BVH ARCHITECTURE

ADDENDUM

PROJECT:	NSC HVAC Replacement and Window Restoration	PROJECT NO.:	BVH: L14077 OCC: 201405
TO:	Prospective Bidders	DATE:	05/16/2018
FROM:	BVH Architecture	ADDENDUM NO.:	5

HEATING HOT WATER AND GLYCOL HOT WATER PIPING SCHEMATIC

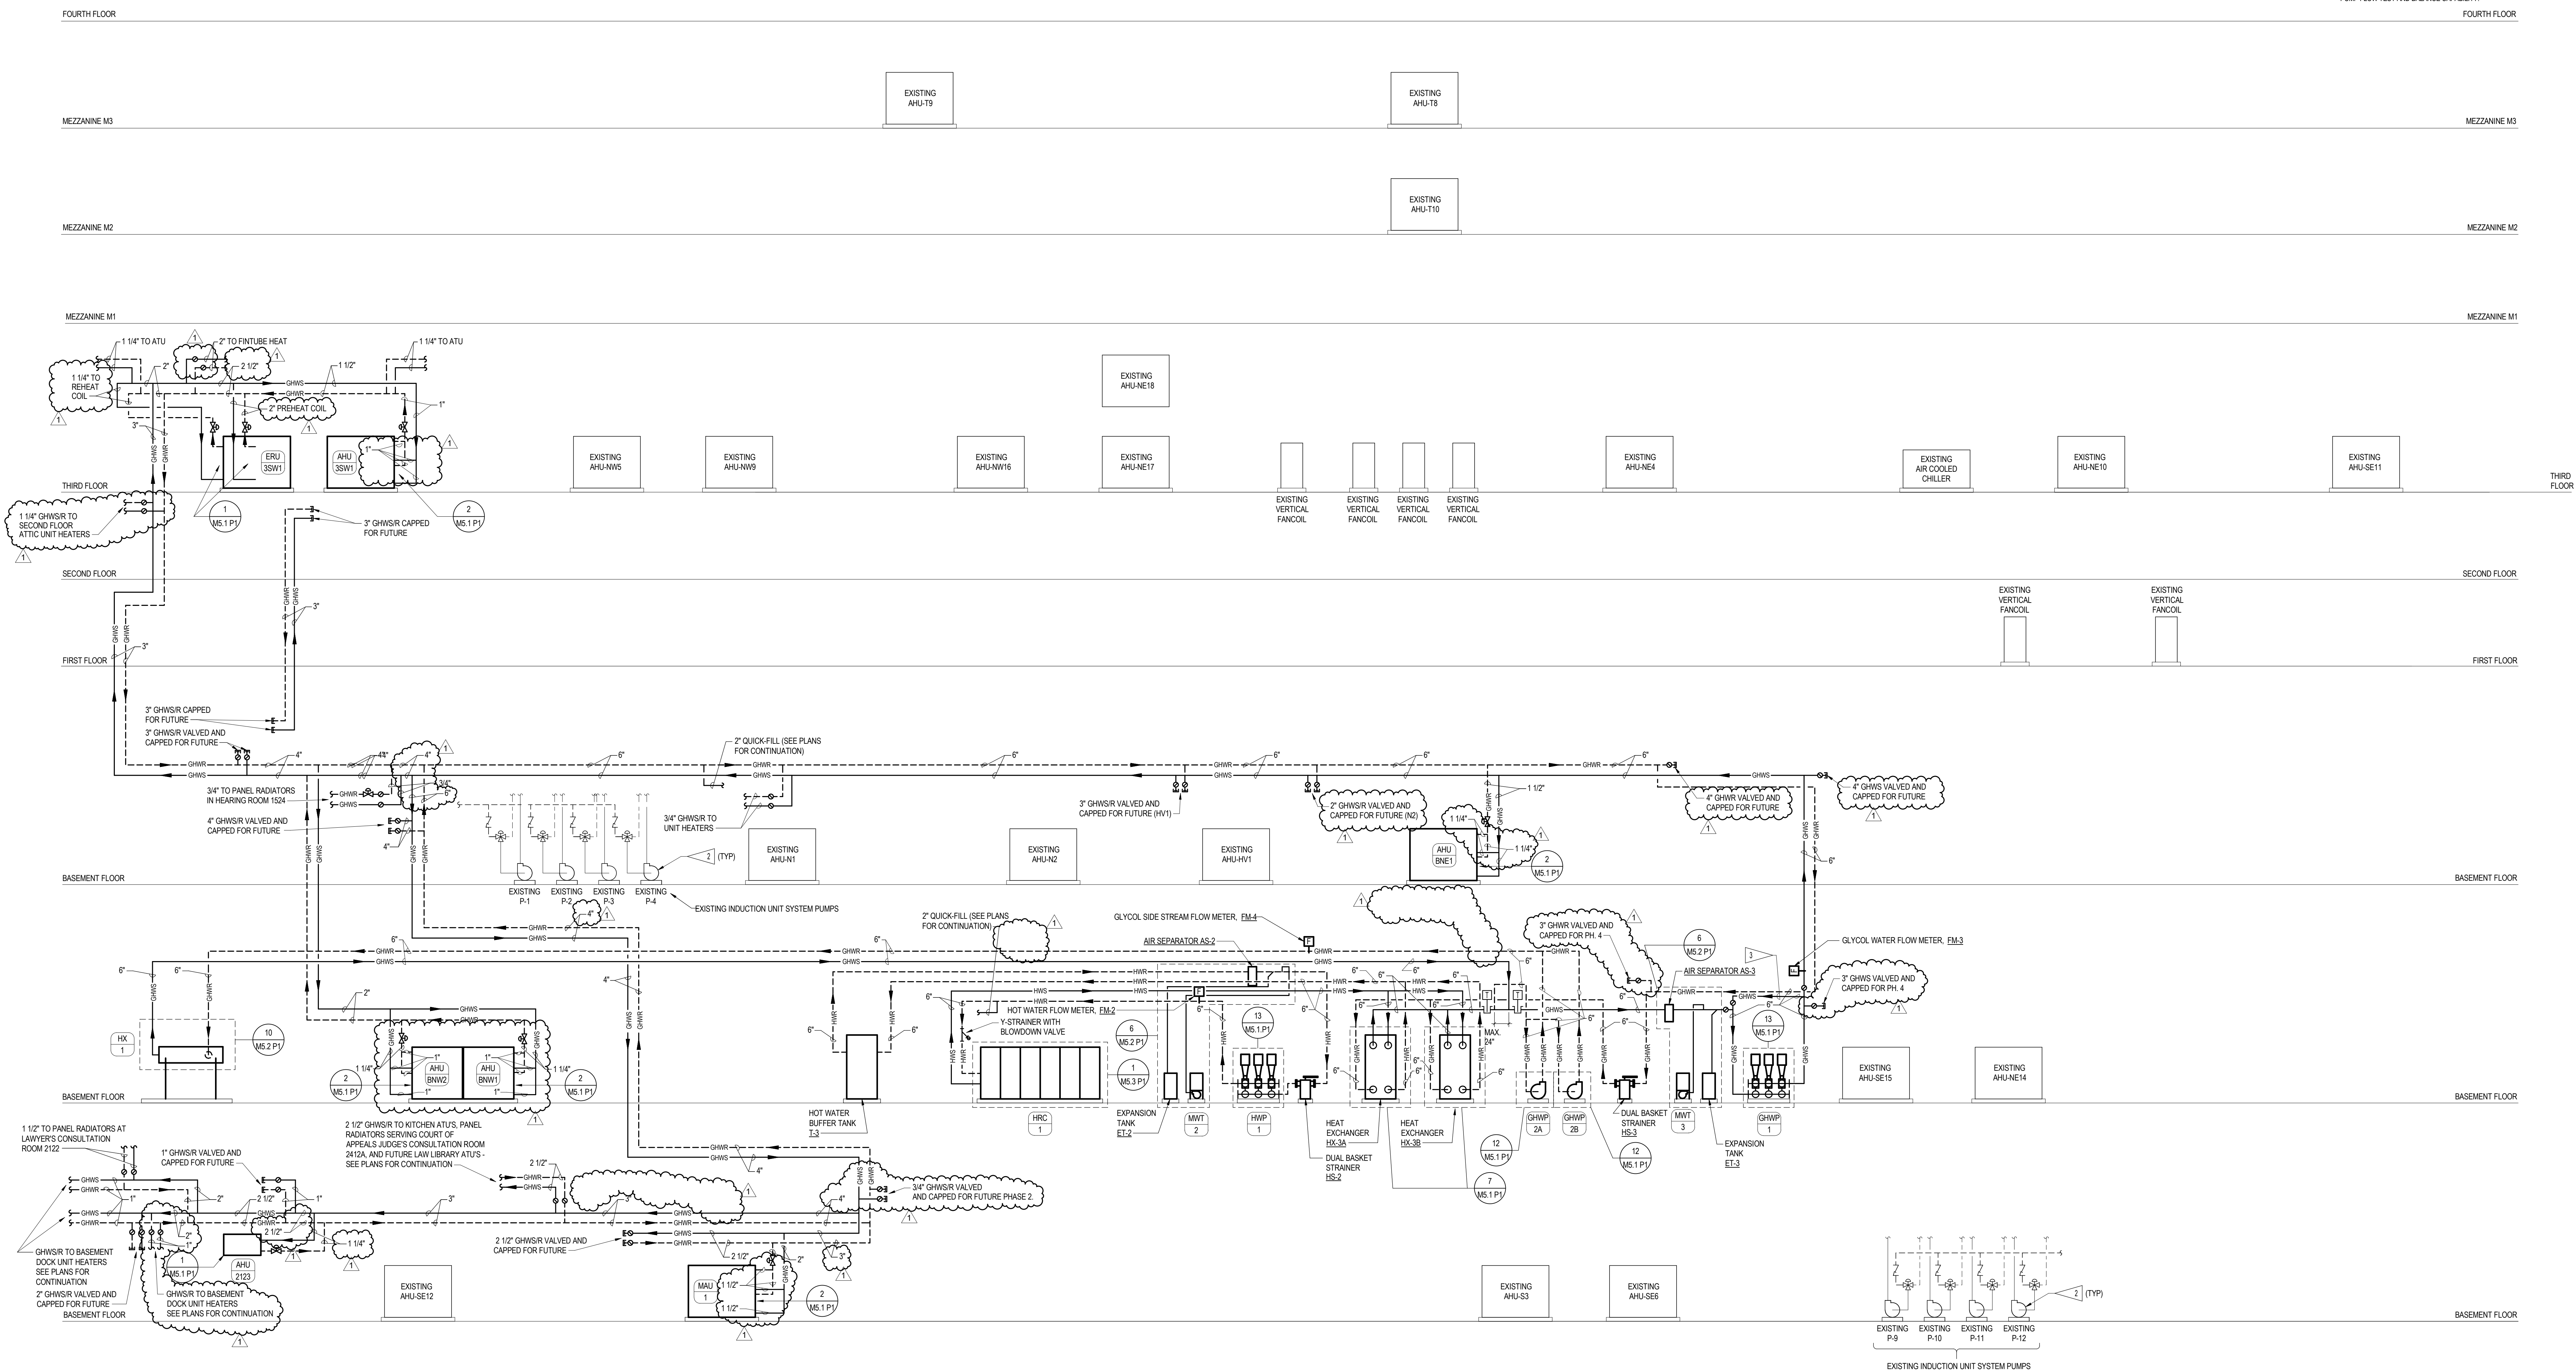
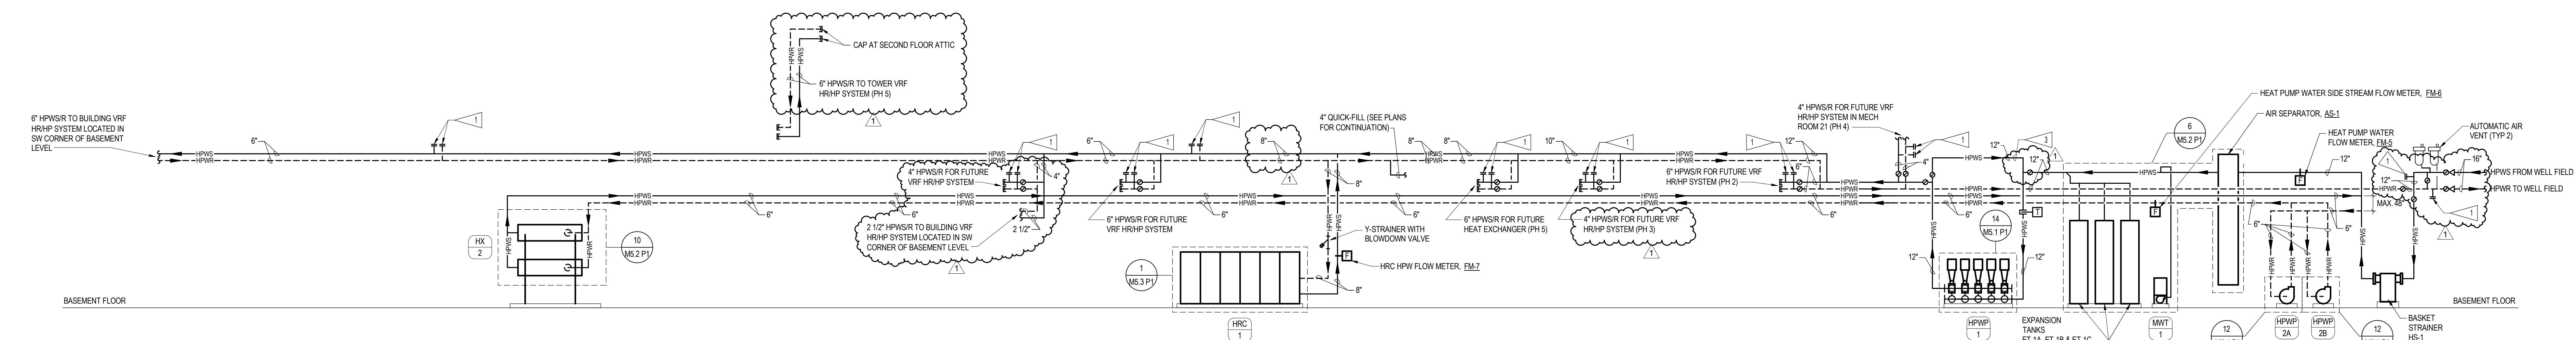
3. Piping General Notes:
 - A. Add Note 14 as follows: “SEE SHEET M4.1 P1 FOR THE HEATING HOT WATER, HEATING GLYCOL HOT WATER, AND HEAT PUMP WATER PIPING SCHEMATICS.”

HEAT PUMP
SUPPLY & RETURN
LINE DETAILS

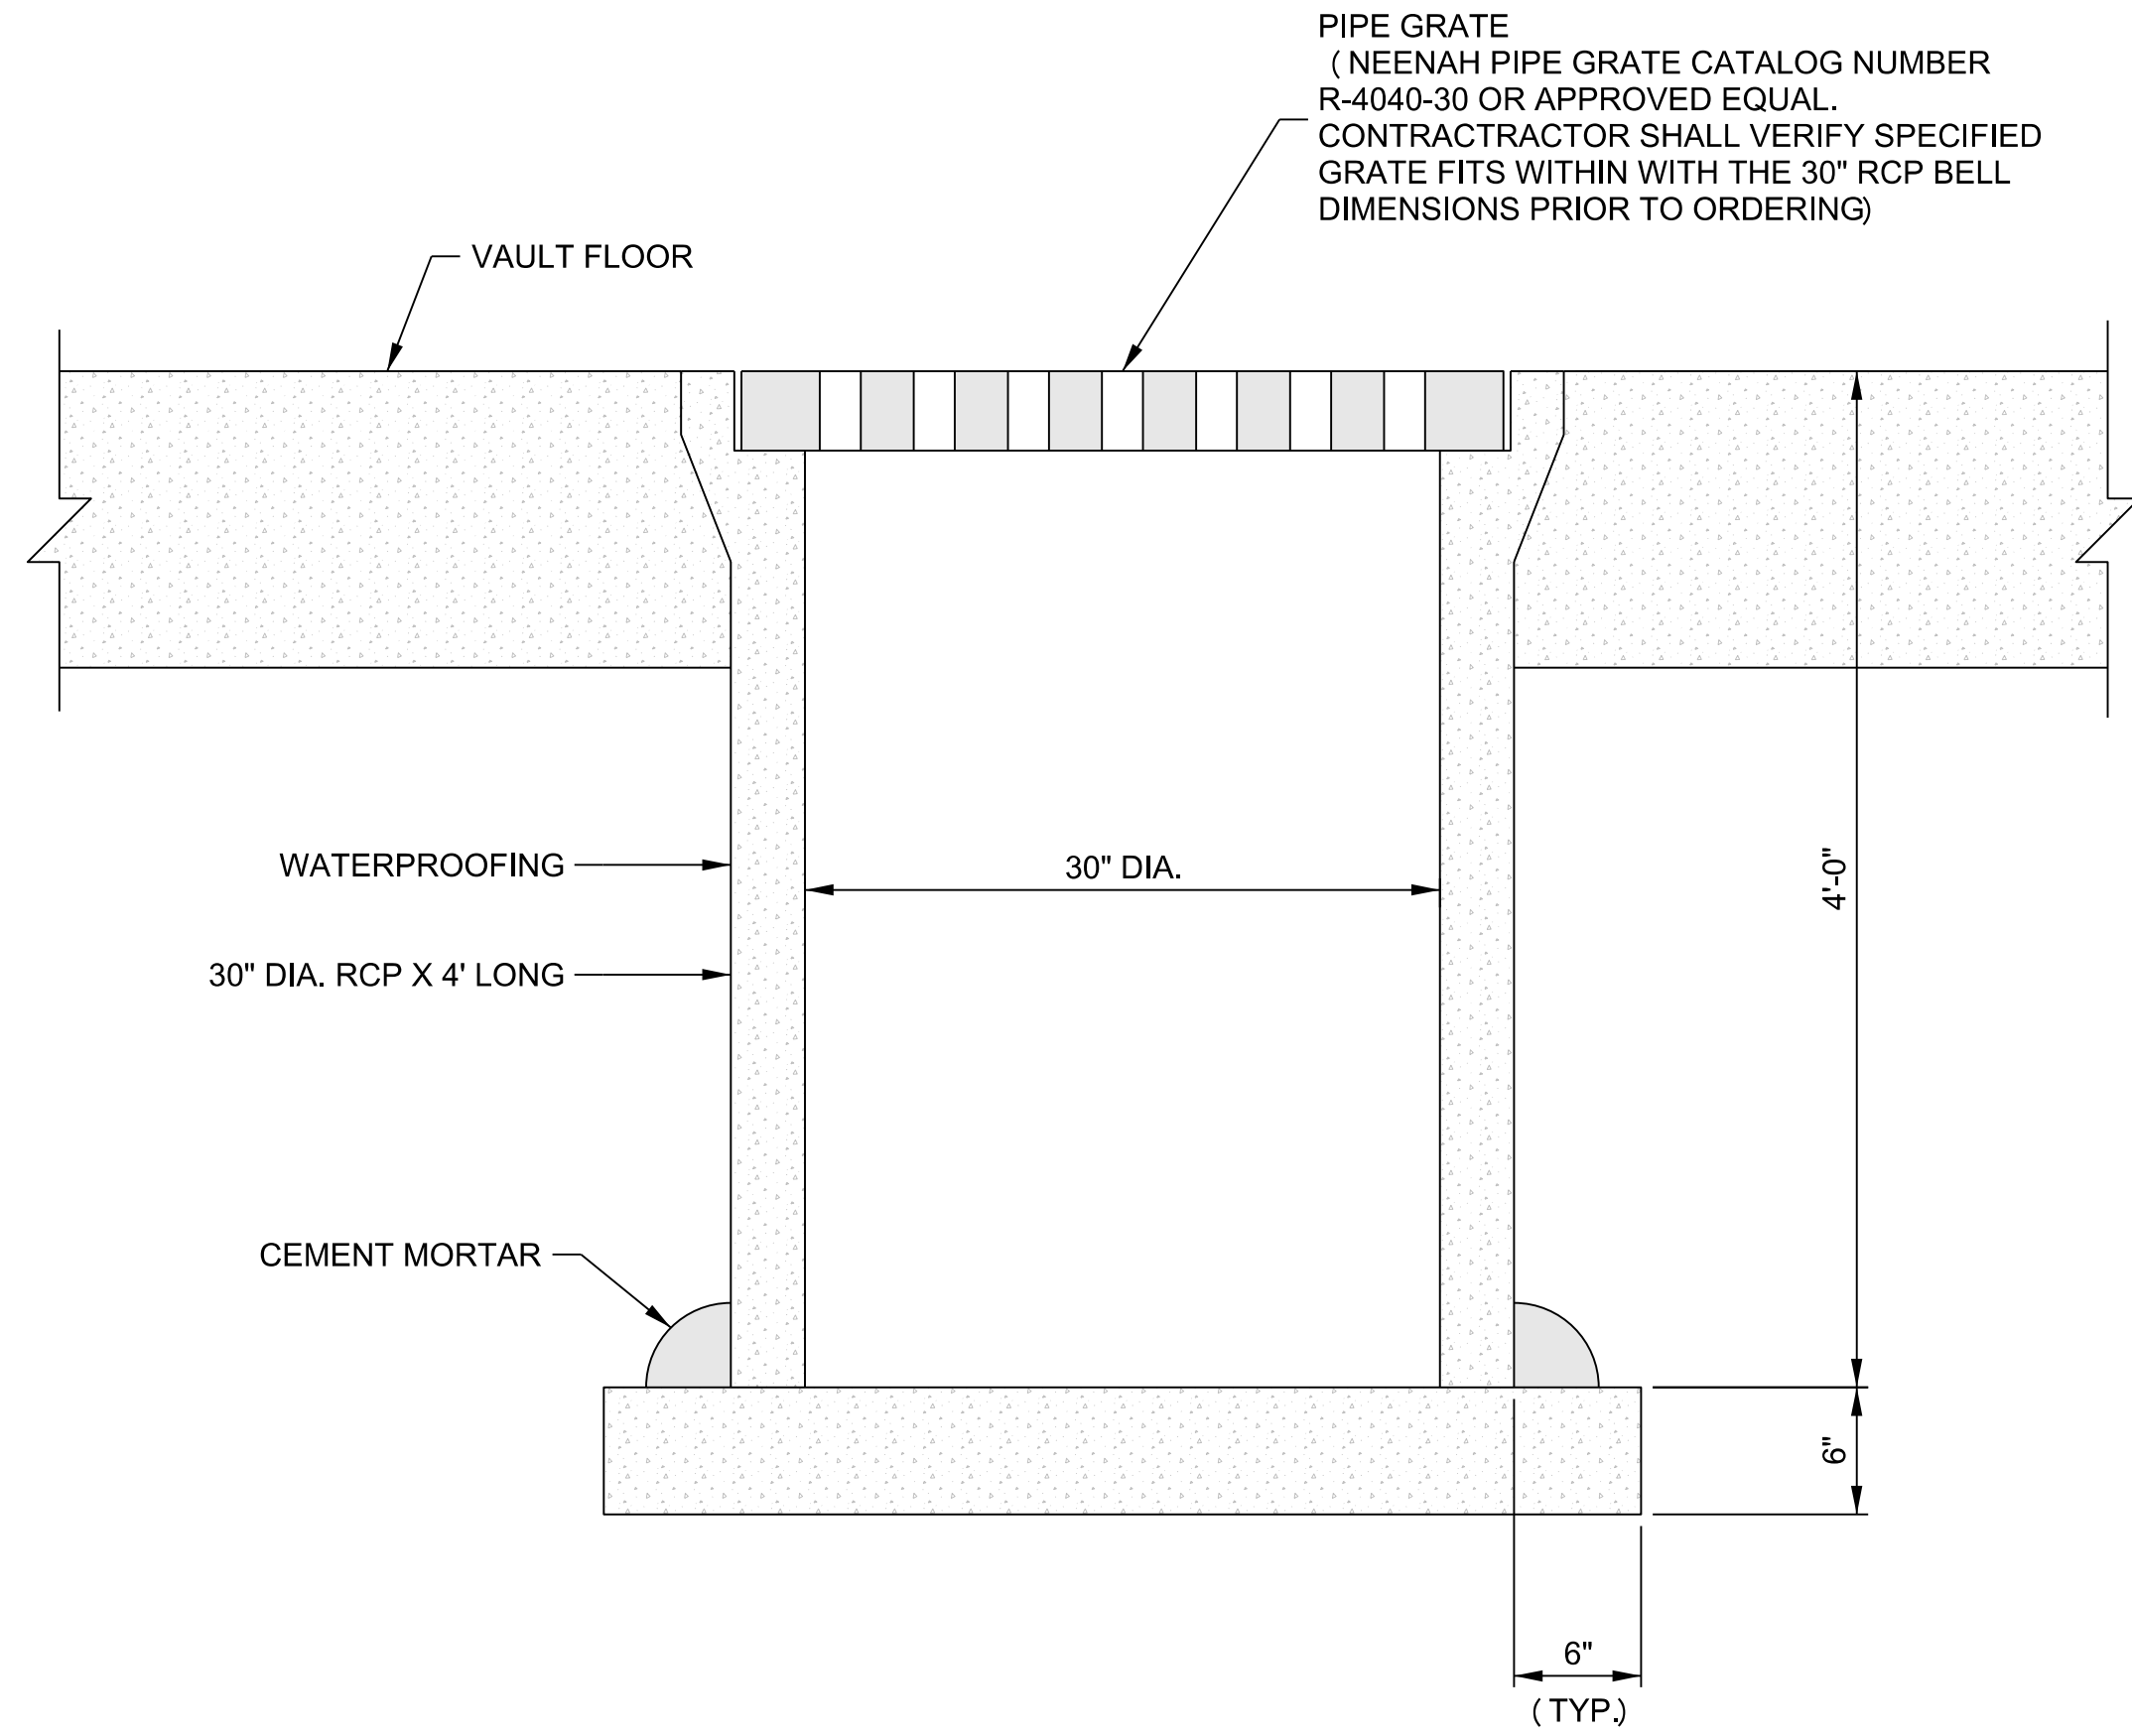
1. ALT-3 C9.5 PB - Phase B Alternate 3 - Parking Lot Area Irrigation Construction Plan
 - b. See attached revised sheet.
3. C17.0 PB - Heat Pump Supply & Return Line Details

- a. CHANGE: Building Wall Penetration Detail
 1. Change the detail note "Hydrostatic pipe wall closure - 'Link Seal' or equal" to read as "Hydrostatic pipe wall closure with 316 stainless steel bolts and nuts - 'Link Seal' or equal per manufacturers specifications."

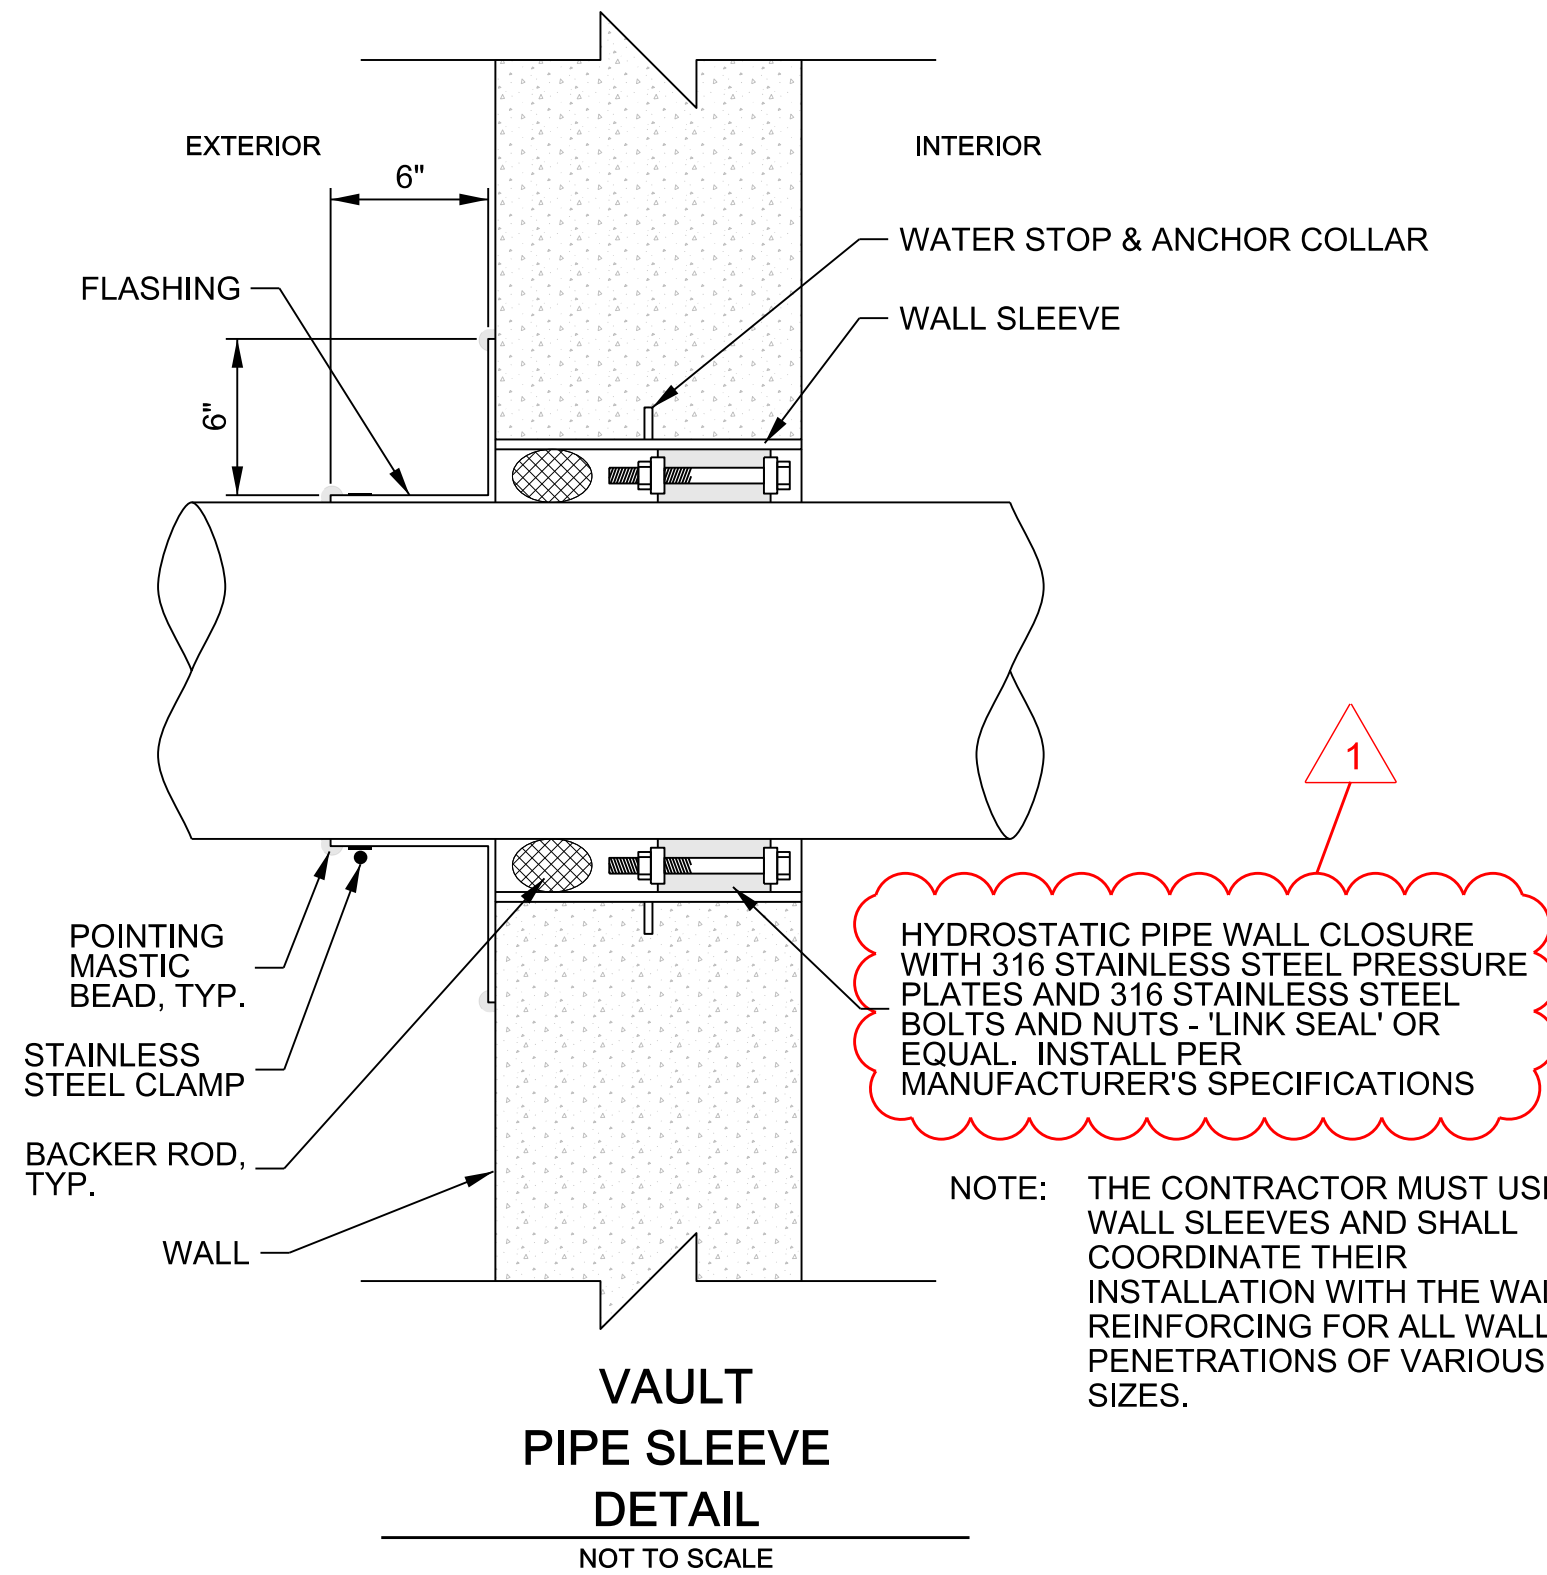
- b. DELETE: Butterfly Valve Detail
 - c. See attached revised sheet.
4. C21.2 PB - Vault Details (Typical Vault Details)
 - a. Vault General Notes:
 1. DELETE "The cast iron manhole ring and cover shall be set in a bed of mortar, and carefully adjusted to proposed grade."

2. DELETE "Each vault shall include a cast iron cover and frame."
 3. DELETE "Casting shall conform to the requirements of specifications for gray iron casting in accordance with A.S.T.M. A-48-83, Class 35B."

4. DELETE "Casting shall be furnished with machined horizontal bearing surfaces."
 5. DELETE "Casting shall be rated 'Heavy Duty' suitable for H-20 traffic loading."
